## REMARKS

DRAWING AMENDMENTS:

The attached sheets of drawings include changes to Figs. 1 and 2. These sheets, which include Figs. 1 - 2, replace the original sheets including Figs. 1 - 2.

FIG. 1

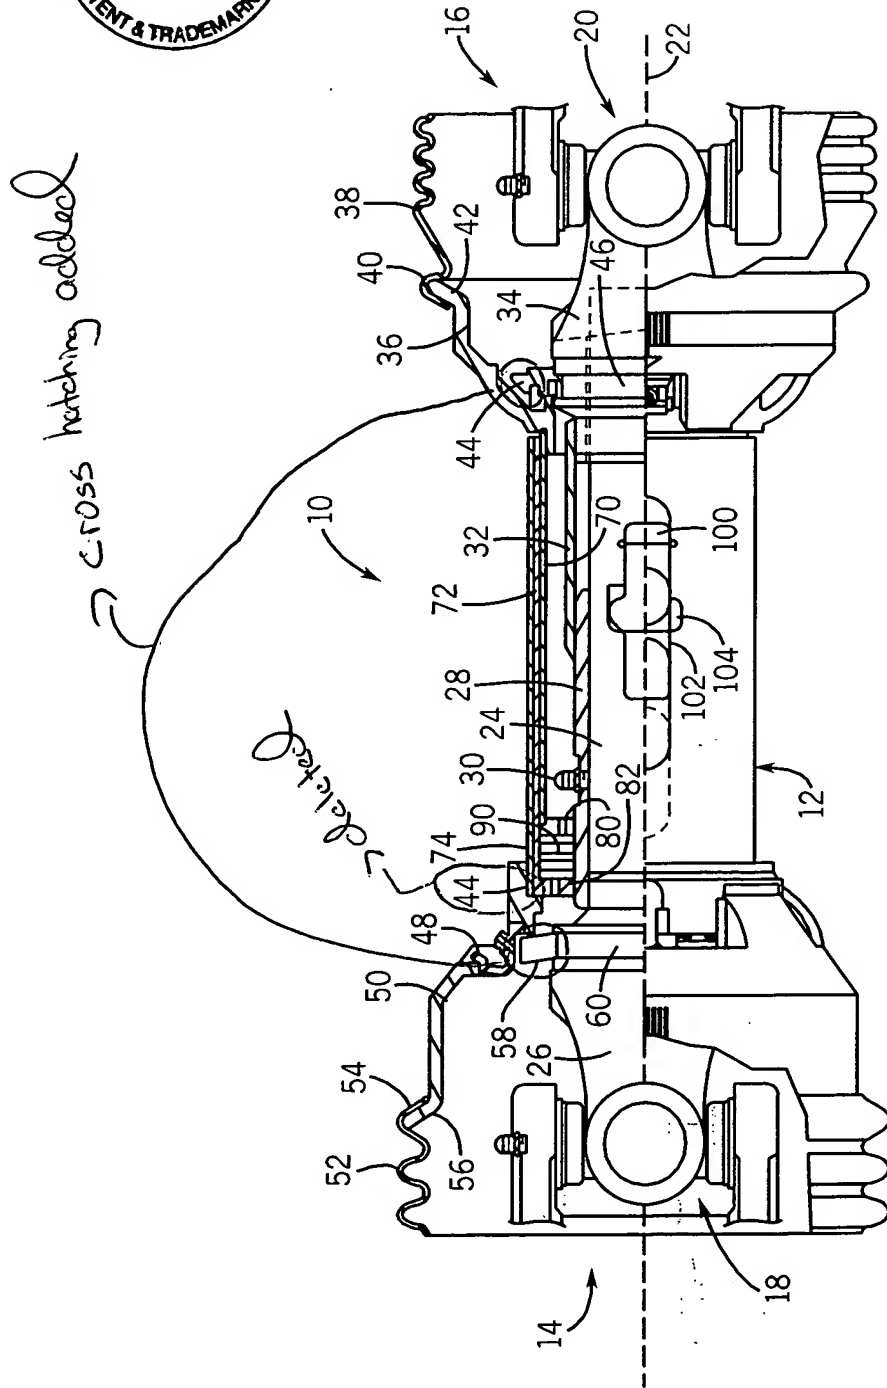
Specifically, the drawings are now shown with proper cross-hatching (alternating heavy and light diagonal lines representing plastic material) for bushings 44 and 48 to address point 2a in the Office action.

An erroneous reference numeral 44 and its lead line were deleted from Fig. 1 to correct a clerical error.

FIG. 2

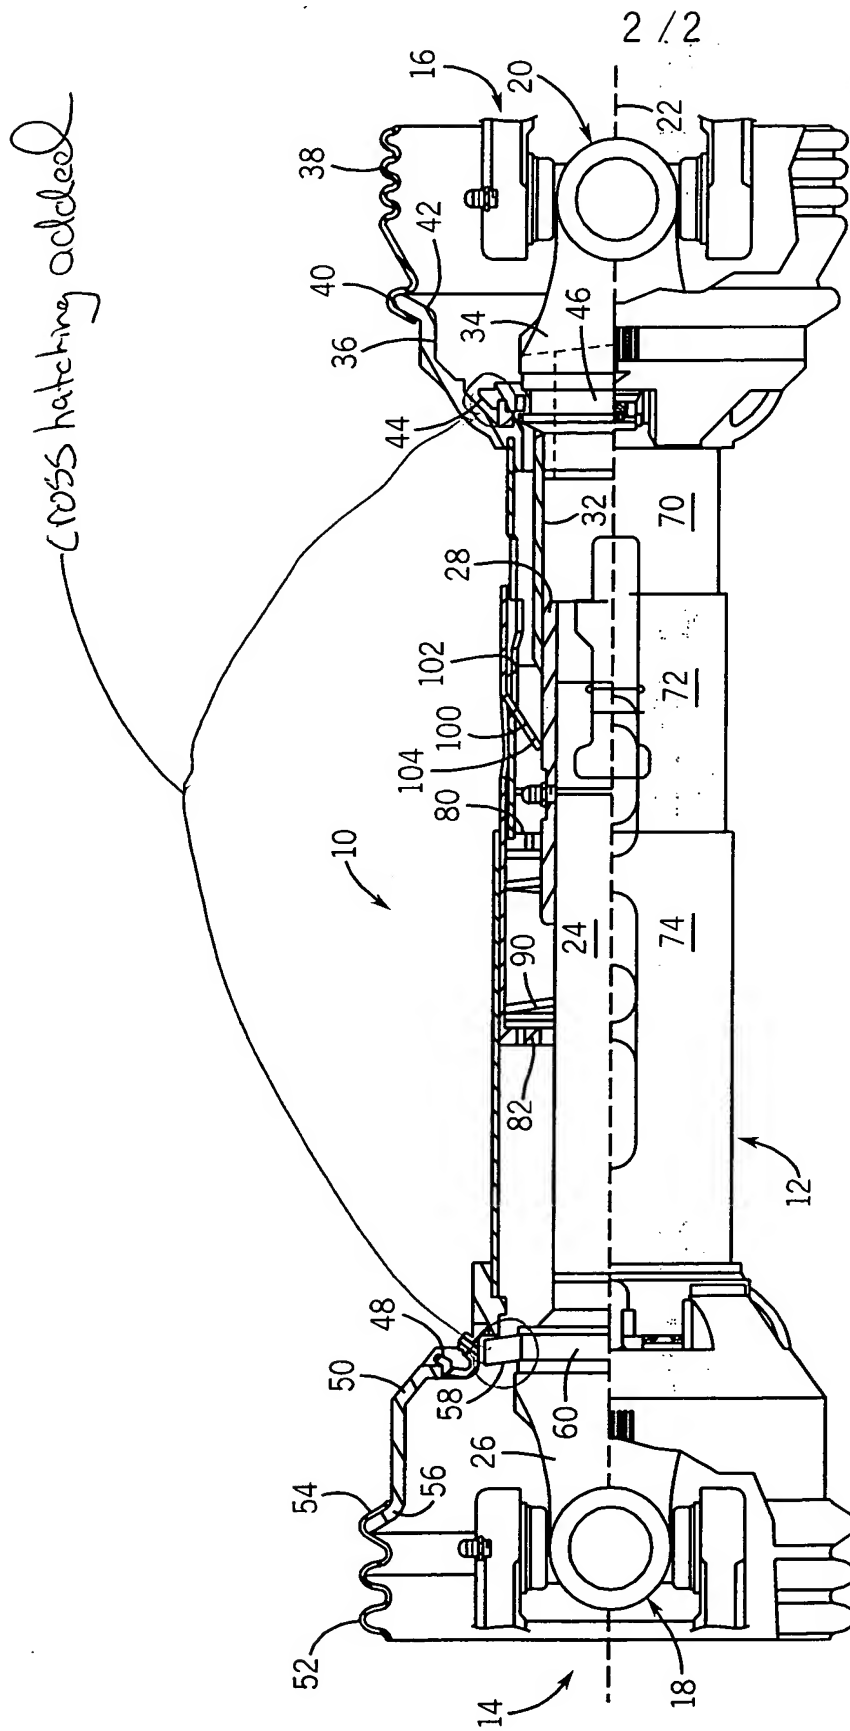
Regarding point 2b, Applicants have amended claims 3 and 13 to replace "acts against the inner guard sleeve to bias" with "biases." Fig. 2 shows that the spring 90 biases (as opposed to acting against) the center guard sleeve axially toward the outer guard sleeve.
